Verification of KML file, DGPS map and Toposheet

Proposal No.: FP/HR/Approach/150903/2022		Date: 8.02.24
Proposal Title: Diversion of 0.0221 Ha forest land for access to Jindal Socks Global Pvt. Ltd. on Samalkha - Dikadla – Hathwala road (ODR), at km stone no. 08 (LHS), Village Dikadla, Tehsil Samalkha, Distt. Panipat (Haryana)		
Area proposed for Diversion (Ha): 0.0221 Ha		
District: Panipat		
<u>PROJECT SITE</u>

Annexure I: Google Earth Imagery of CA Site showing all the parts location.

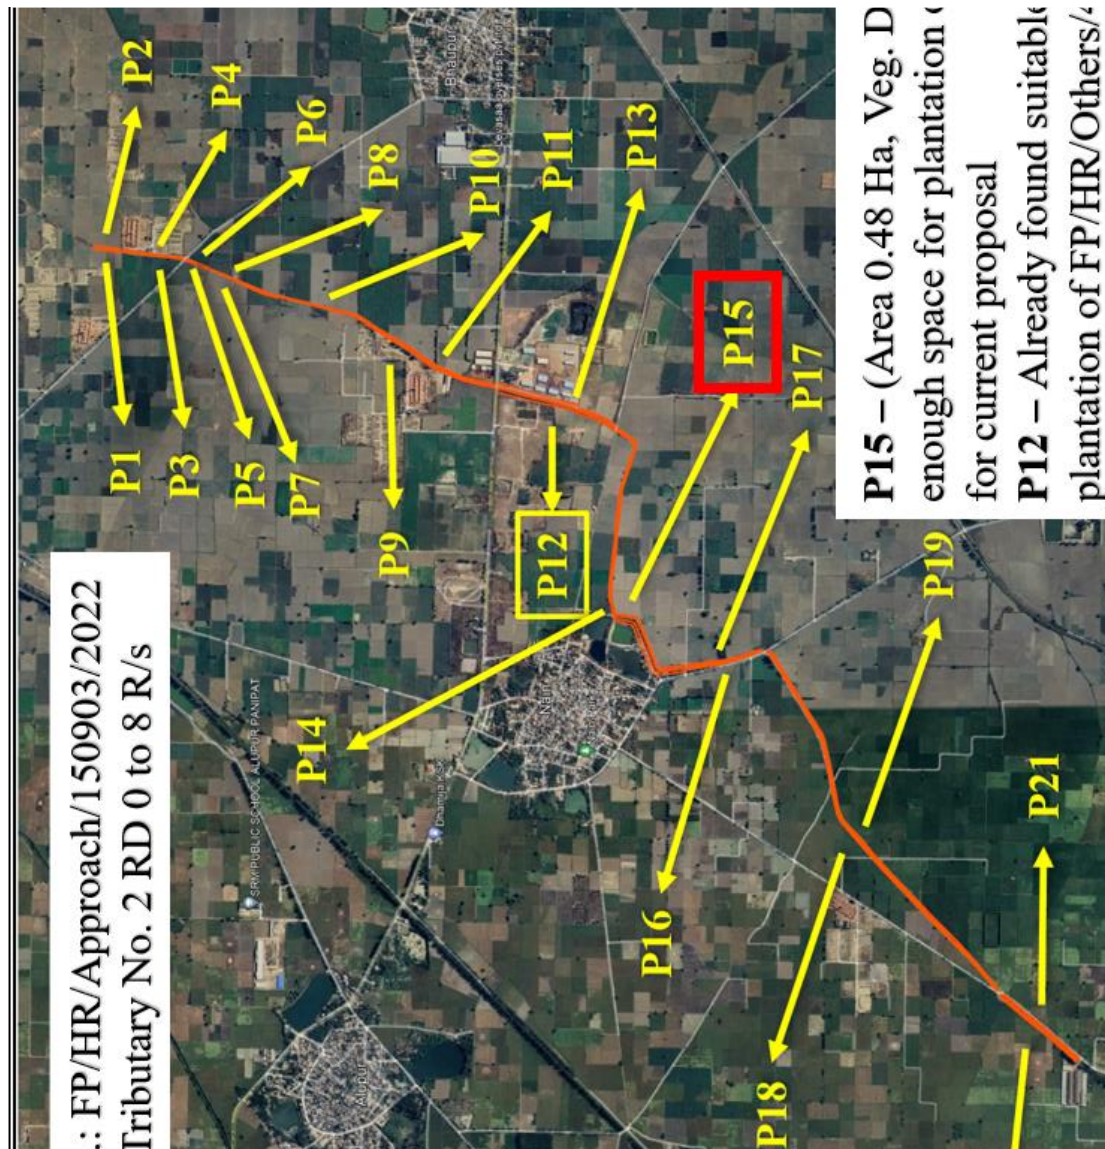
1.	KML File	<p>INCORRECT:</p> <p>i. The KML file for CA site <u>contains 21 parts</u> and have a total area of <u>5.7 Ha</u> which is <u>at least 46 times the area required</u> for the proposed plantation i.e. 0.12 Ha. Refer Annexure I & II for more details.</p> <p>ii. The KML file is <u>exactly same as the CA site proposed in the Proposal No. FP/HR/Others/404568/2022.</u> In this Proposal, <u>Part No. 12</u> of this CA site was found suitable for the target plantation.</p> <p>iii. For the current case, only one part, <u>Part No. 15 is enough</u> for the proposed plantation as it has an area of 0.48 Ha and a vegetation density of 0.4</p> <p>iv. All other parts are not required for this case and can be utilised for CA plantation in other cases. Refer Annexure II for part wise remarks.</p> <p>v. Please revise the KML file to include only Part No. 15 for the CA of current proposal</p>

- Part 12 which was found suitable for CA in Proposal No. FP/HR/Others/404568/2022 is highlighted in Blue.
- The Part 15 which is enough for the proposed plantation of current case is highlighted in Green
